Office Action Summary	Application No.	Applicant(s)	
	10/617,628	SERKH ET AL.	
	Examiner Marcus Charles	Art Unit 3682

DETAILED ACTION

This action is responsive to the Amendment filed 12-20-2006 and RCE filed 02-23-2007, which have been entered. Claims 1-13 are currently pending.

Fig. 1

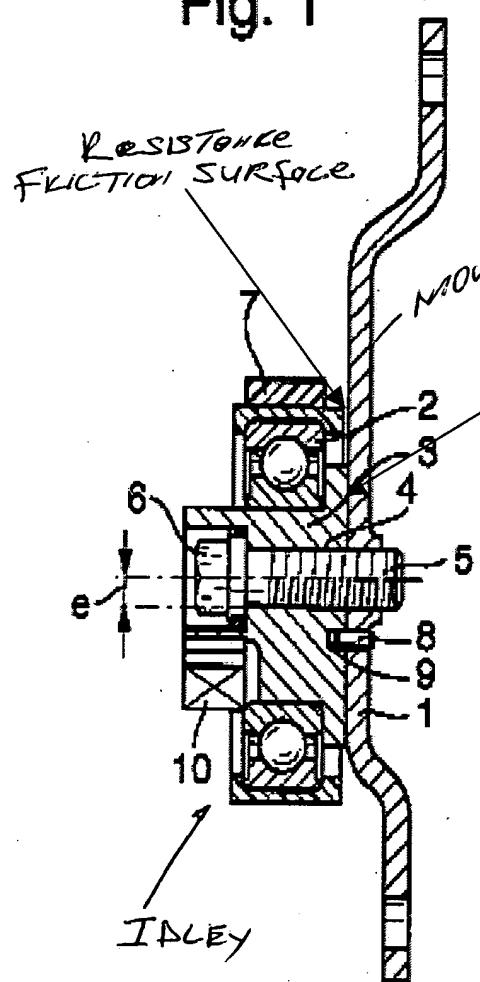
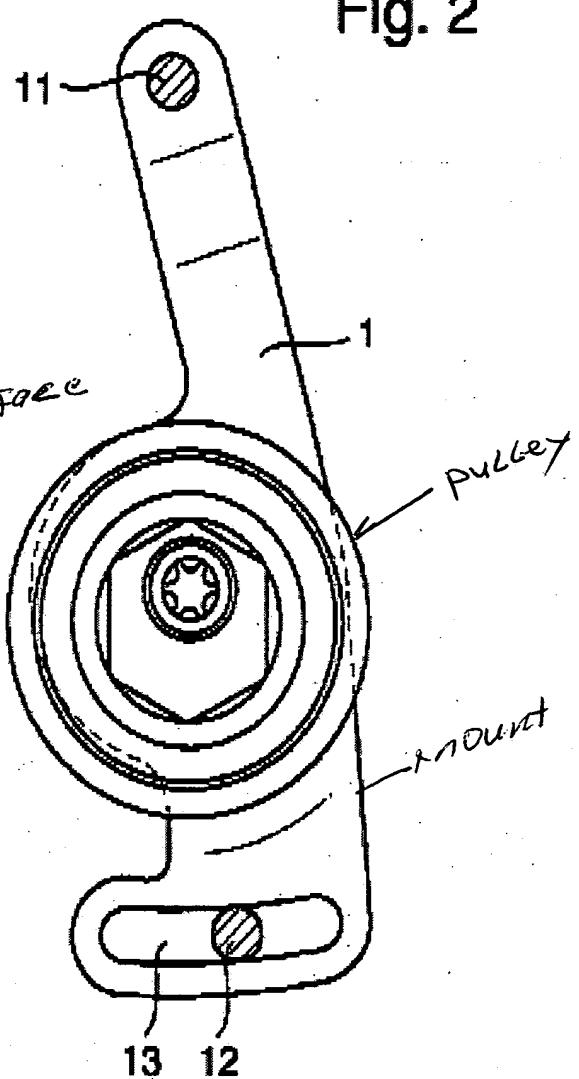
5. Claims 1-13 are rejected under 35 U.S.C. 102(b) as being anticipated by Bruchner et al. (5,820,503). Bruchner et al. discloses an idler comprising a pulley supported by a bearing (2) mount on a bearing mount which is mounted on a tension adjusted member (3, bearing mount), wherein the tension-adjusting member is in communication with a fastener (5/6) that fixes the idler to a mount (1). It is apparent that as the fastener (5/6) fixes the idler to the mount, the bearing mount (3) will actually rotate in the direction of the turning action of the fastener due to frictional torque between the contact surfaces of the fastener and the bearing mount thereby inherently tensioning on the belt.

In claim 2, note the tension adjusting member is a cylinder that cooperates with the inner portion of the bearing (2), and an eccentric bore axially therethrough.

In claim 3, note the tension adjuster comprises a reaction friction surface and a resistance surface (see attached drawing). In addition, it would be inherent for the idler

In claim 4, note the reaction resistance surface with a reaction-mating surface of the fastener and the resistance friction with the mounting surface.

Regarding claim 5, note the arm (1) having a pulley mounting portion and a dual fastener bore at (11) at one end.

In claim 6, note the curve slot (9) in the cylindrical portion of the tension-adjusting member.
